Re: Amendment for Addition of
Shop and Storage Containers
Savage Service Corporation
Savage Coal Terminal
C/007/0022

Permittee: Savage Services Corporation
Mine: Savage Coal Terminal **Permit Number:** C/007/0022
Title: Addition of Shop and Storage Containers
Description, Include reason for application and timing required to implement:
To clarify structures and update facility map.

APPENDIX 5-6

Addition of Shop and Storage Containers

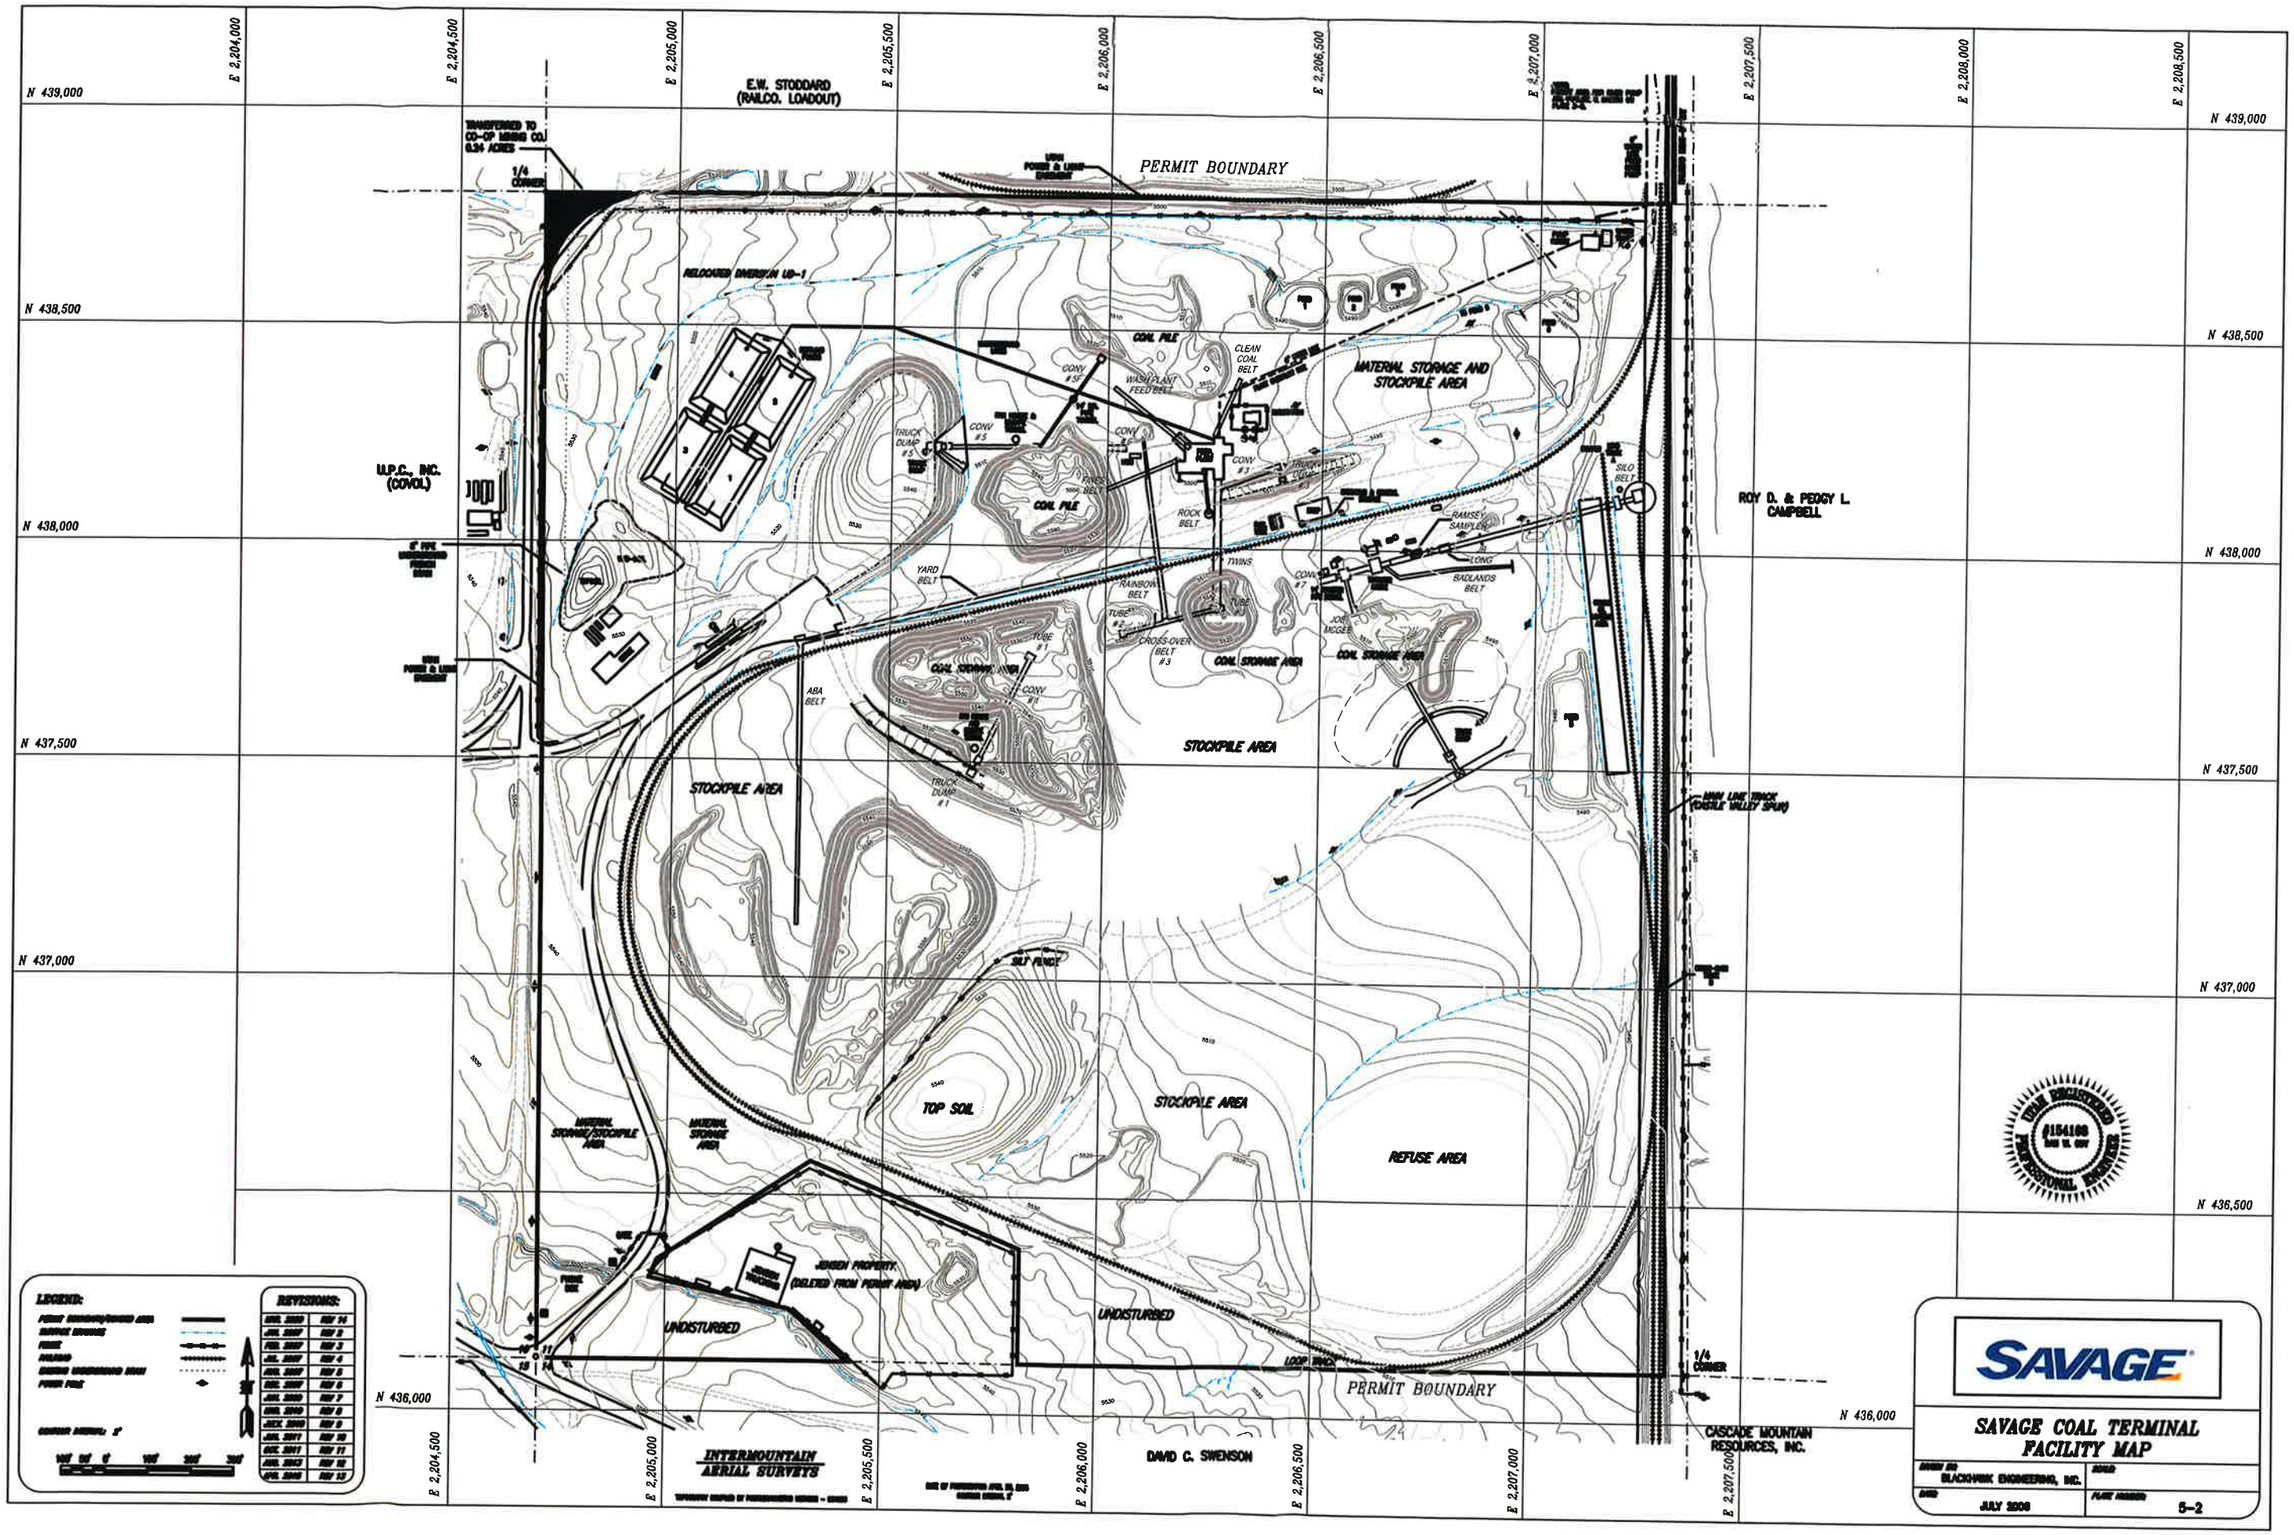
Enclosed are 3 copies of a proposed amendment for the addition of a shop and storage containers for the Savage Coal Terminal MRP. The amendment is being submitted as an appendix to Chapter 5 of the MRP, along with an updated Surface Facilities Map – Plate 5-2 showing the location of the additions.

3 portable steel containers have been placed behind the Savage Coal Terminal office building. Two of the containers are 8' wide by 40' long, and one is 8' wide by 20' long. In addition, a 30' x 40' x10' steel building has been placed to provide a new mechanic shop area. The previous shop area adjacent to the office has been converted to an electrical shop. The metal building has been erected on a previously poured concrete pad with piers. The Surface Facility Map, Plate 5-2 has been updated to show the location of the structures. Bonding cost details are included in this appendix.

The previous outside storage area behind the Savage Coal Terminal office has been modified by removal of the chain link fence and the addition of 3 steel storage containers. In addition, a 30' x 40' x 10' steel building has been erected on a pre-existing concrete pad, to serve as a mechanic shop. Bonding costs for the addition have been provided and show no need for an increase in the bond for this project. The Surface Facility Map, Plate 5-2 has been updated to reflect the changes described herein.
